MIDDLESEX COUNTY COLLEGE
Edison, New Jersey 08818-3050

ADDENDUM NUMBER 1

BID # 17-33- Digital Media Presentation System

SH 203

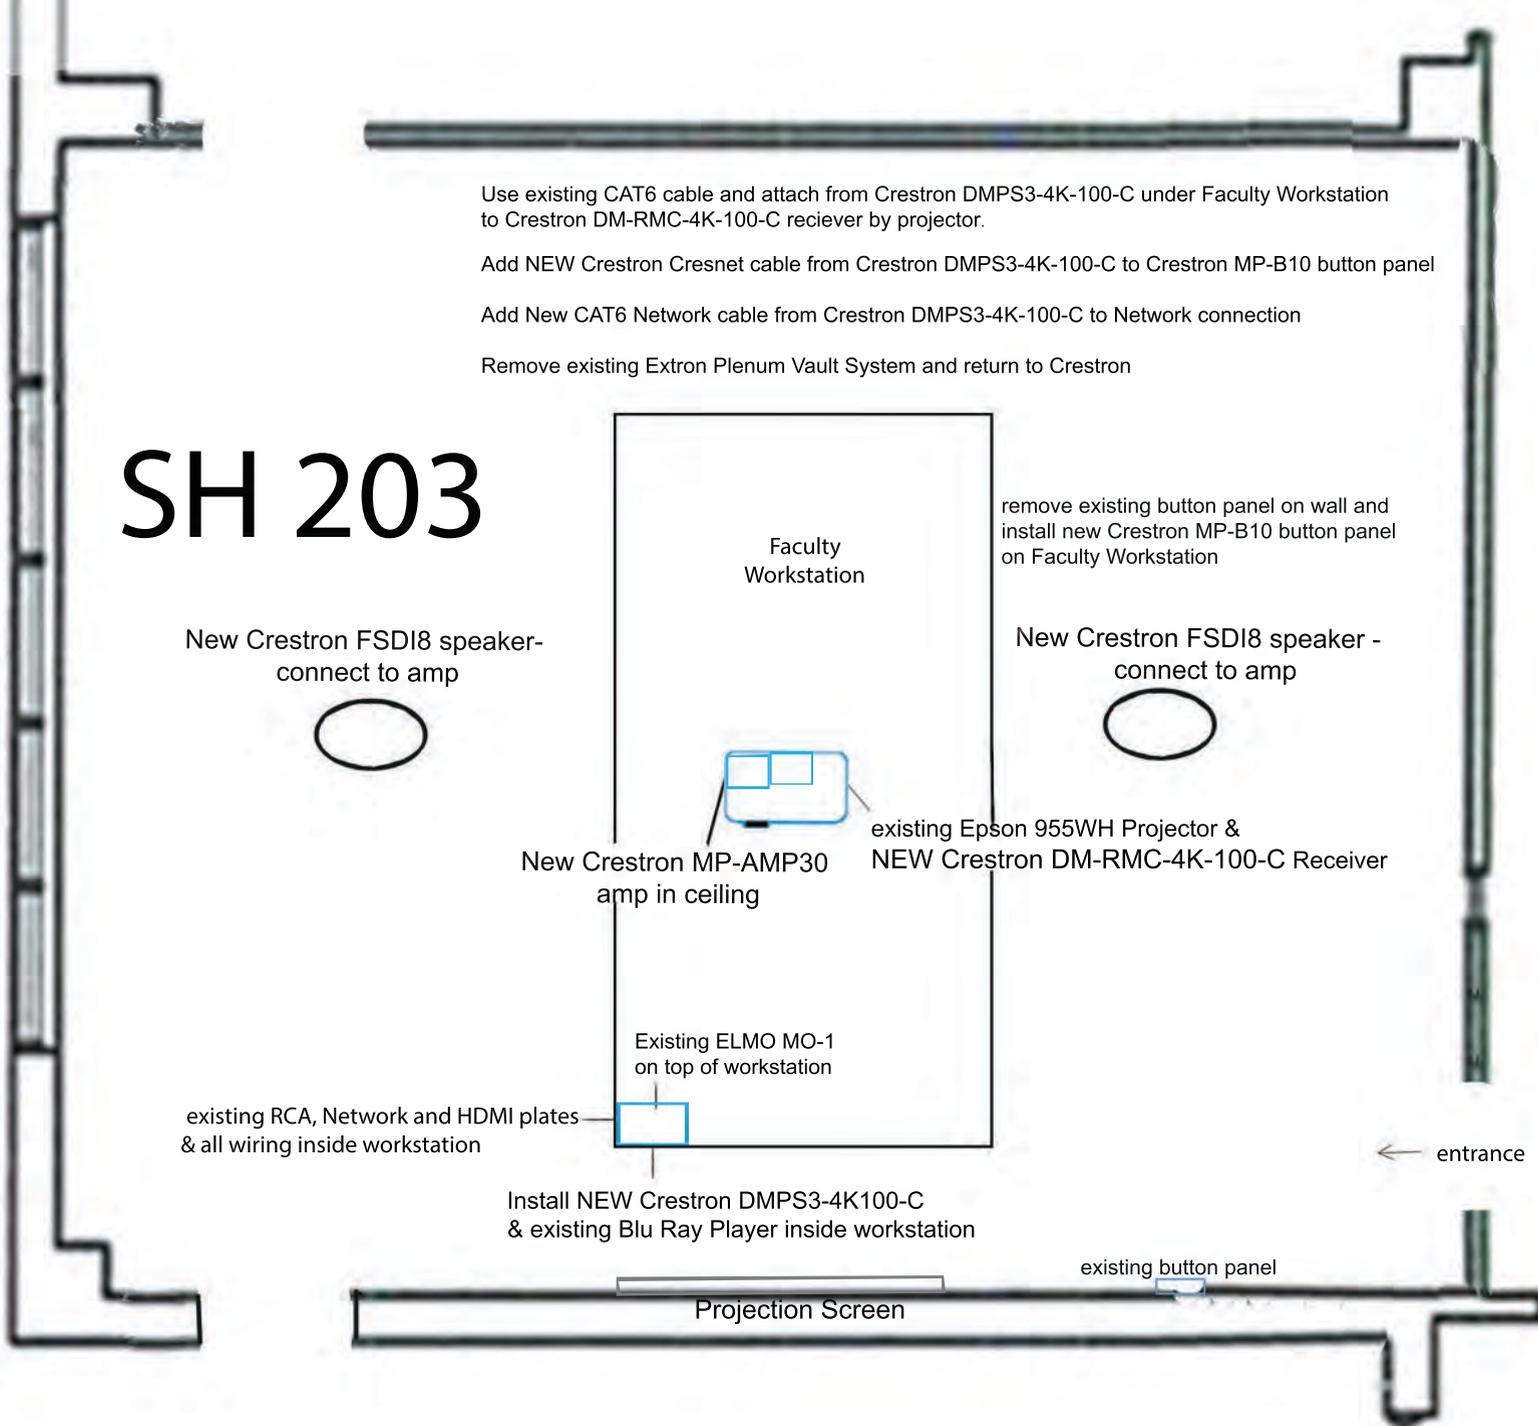
Use existing CAT6 cable and attach from Crestron DMPS3-4K-100-C under Faculty Workstation to Crestron DM-RMC-4K-100-C receiver by projector.

Add NEW Crestron Cresnet cable from Crestron DMPS3-4K-100-C to Crestron MP-B10 button panel

Add New CAT6 Network cable from Crestron DMPS3-4K-100-C to Network connection

Remove existing Extron Plenum Vault System and return to Crestron

remove existing button panel on wall and
install new Crestron MP-B10 button panel
on Faculty Workstation

SH 205

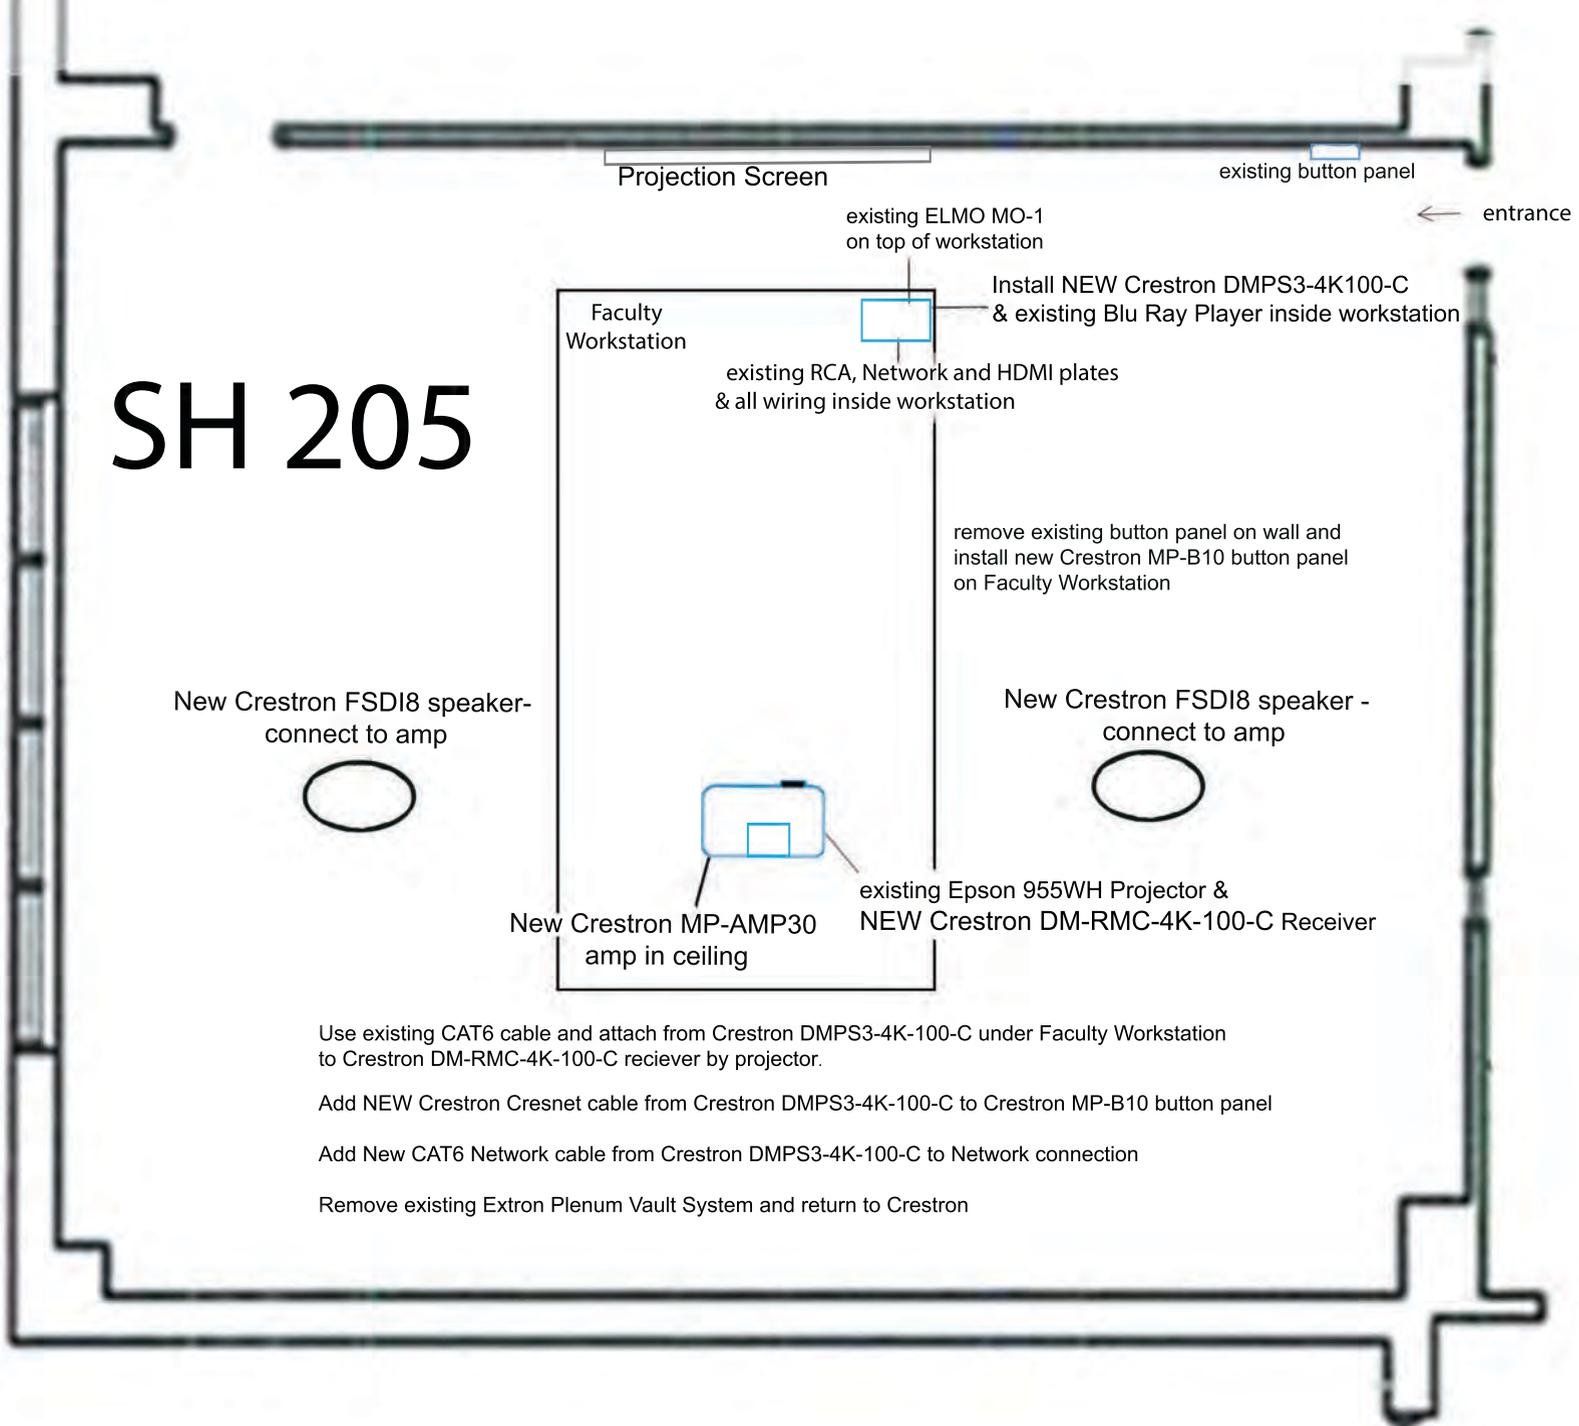
Use existing CAT6 cable and attach from Crestron DMPS3-4K-100-C under Faculty Workstation to Crestron DM-RMC-4K-100-C receiver by projector.

Add NEW Crestron Cresnet cable from Crestron DMPS3-4K-100-C to Crestron MP-B10 button panel

Add New CAT6 Network cable from Crestron DMPS3-4K-100-C to Network connection

Remove existing Extron Plenum Vault System and return to Crestron

SH 212

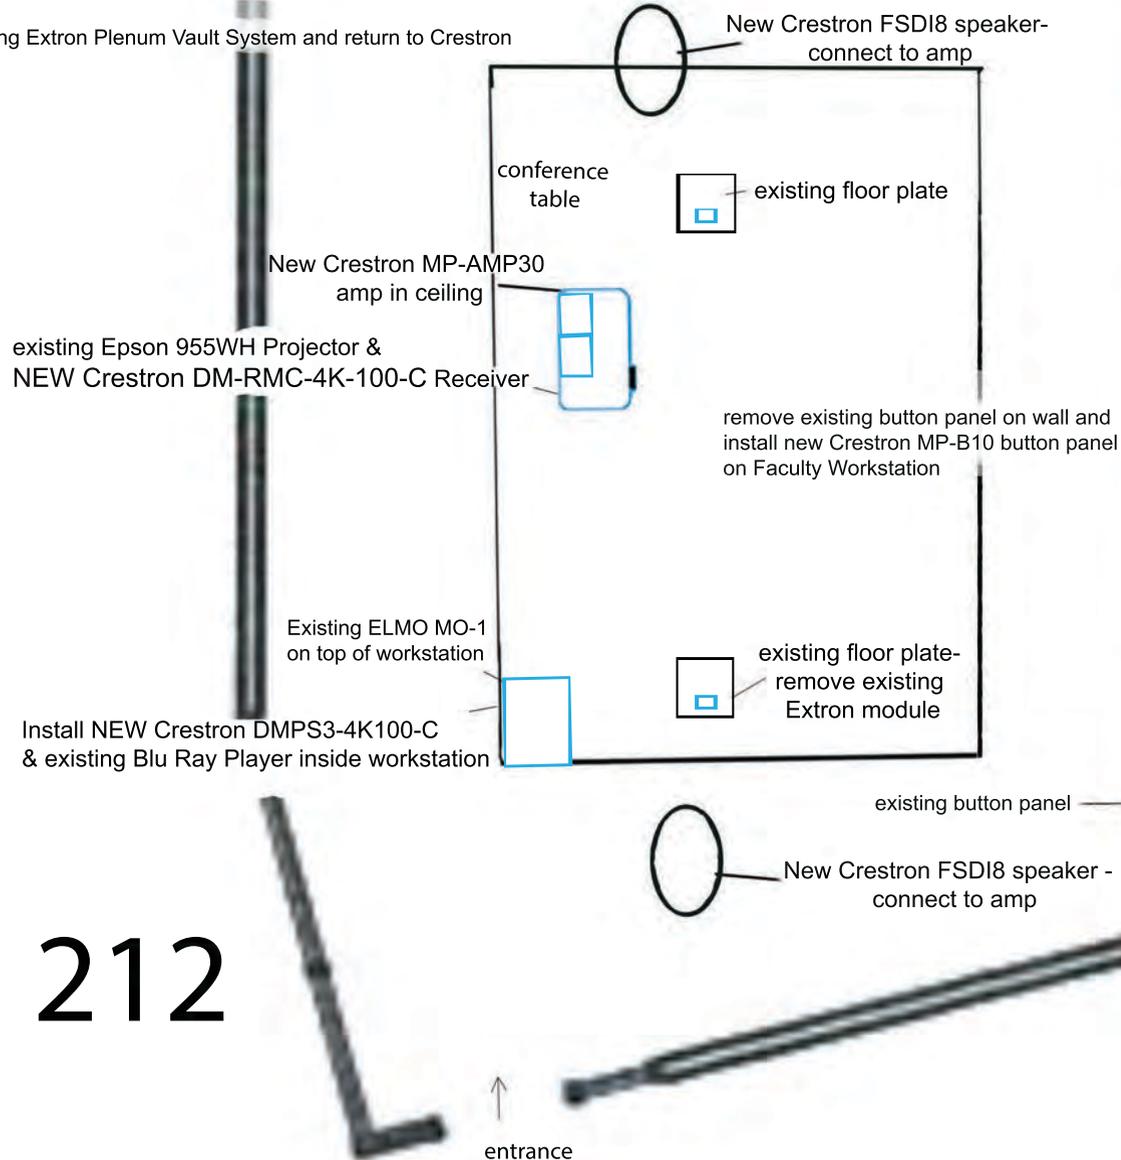
Use existing CAT6 cable and attach from Crestron DMPS3-4K-100-C under conference table to Crestron DM-RMC-4K-100-C receiver by projector.

Add NEW Crestron Cresnet cable from Crestron DMPS3-4K-100-C to Crestron MP-B10 button panel

Add New CAT6 Network cable from Crestron DMPS3-4K-100-C to Network connection

Remove existing Extron Plenum Vault System and return to Crestron

SH 231

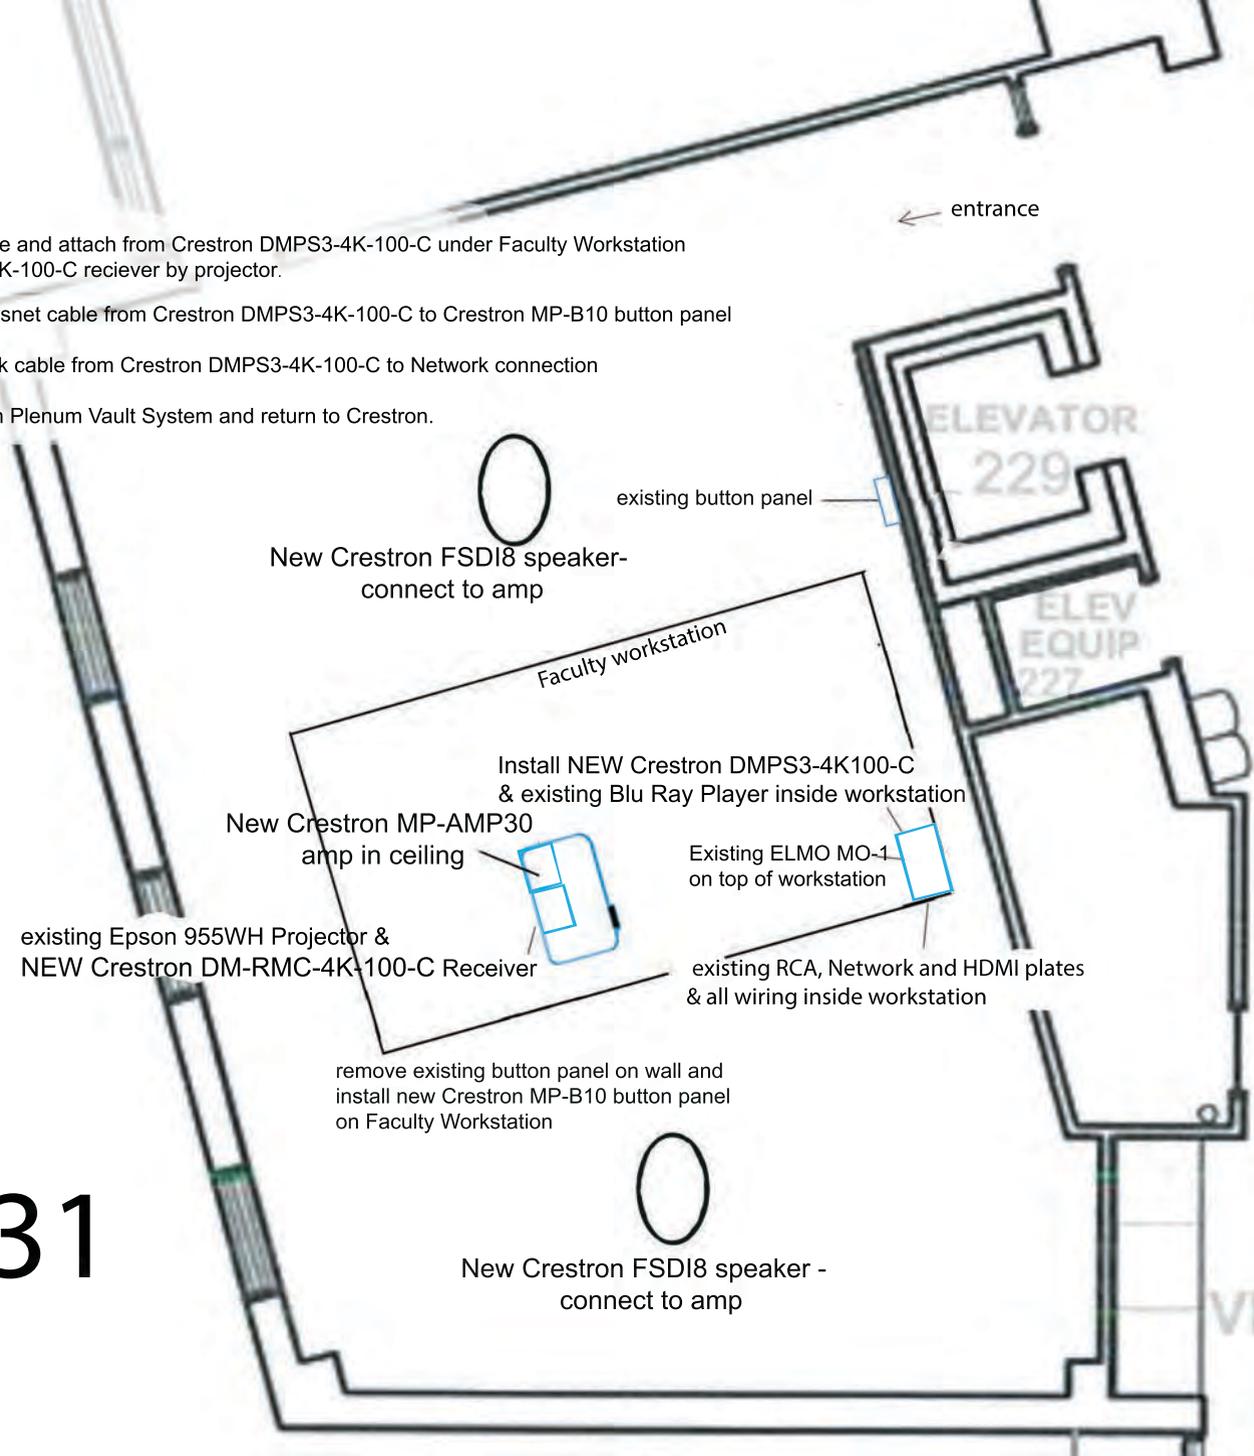
Use existing CAT6 cable and attach from Crestron DMPS3-4K-100-C under Faculty Workstation to Crestron DM-RMC-4K-100-C receiver by projector.

Add NEW Crestron Cresnet cable from Crestron DMPS3-4K-100-C to Crestron MP-B10 button panel

Add New CAT6 Network cable from Crestron DMPS3-4K-100-C to Network connection

Remove existing Extron Plenum Vault System and return to Crestron.

remove existing button panel on wall and install new Crestron MP-B10 button panel on Faculty Workstation

SH 235

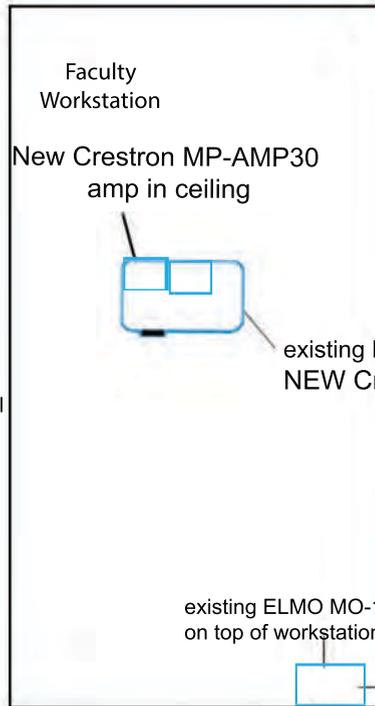
Use existing CAT6 cable and attach from Crestron DMPS3-4K-100-C under Faculty Workstation to Crestron DM-RMC-4K-100-C receiver by projector.

Add NEW Crestron Cresnet cable from Crestron DMPS3-4K-100-C to Crestron MP-B10 button panel

Add New CAT6 Network cable from Crestron DMPS3-4K-100-C to Network connection
Remove existing Extron Plenum Vault System and return to Crestron

remove existing button panel on wall and
install new Crestron MP-B10 button panel
on Faculty Workstation

SH 239

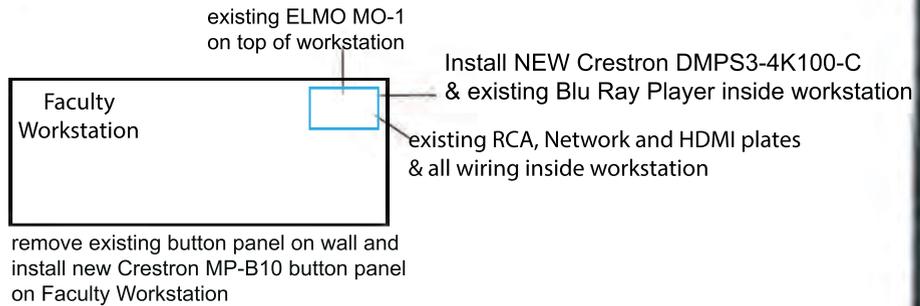
Use existing CAT6 cable and attach from Crestron DMPS3-4K-100-C under Faculty Workstation
to Crestron DM-RMC-4K-100-C receiver by projector.

Add NEW Crestron Cresnet cable from Crestron DMPS3-4K-100-C to Crestron MP-B10 button panel

Add New CAT6 Network cable from Crestron DMPS3-4K-100-C to Network connection

Remove existing Extron Plenum Vault System and return to Crestron
